**Project: IEEE P802.15 Working Group for Wireless Personal Area Networks (WPANs)**

**Submission Title:** [TRD comments from Samsung Part 1]

**Date Submitted:** [12 May, 2009]

# **TRD Comments from Samsung Electronics – Part 1 –**

### ■ Tx power

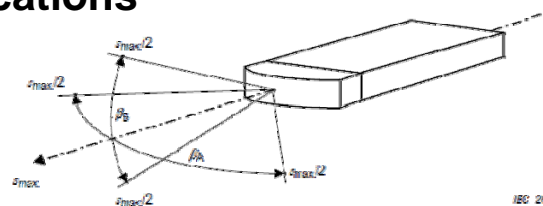
#### ◆ Maximum Intensity:

- Eye safety regulation
  - For example: IEC 60825
  - For example: letter to IEC TC 76.

# Frequency Reuse

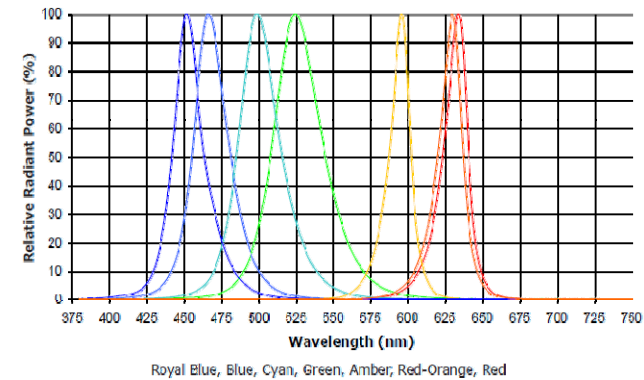
## ❖ We need to consider real LED specification

- Need to support at least RGB & White

- Consideration

- ◆ LED manufacture's variation
- ◆ LED communication ability (ability for fast switching)
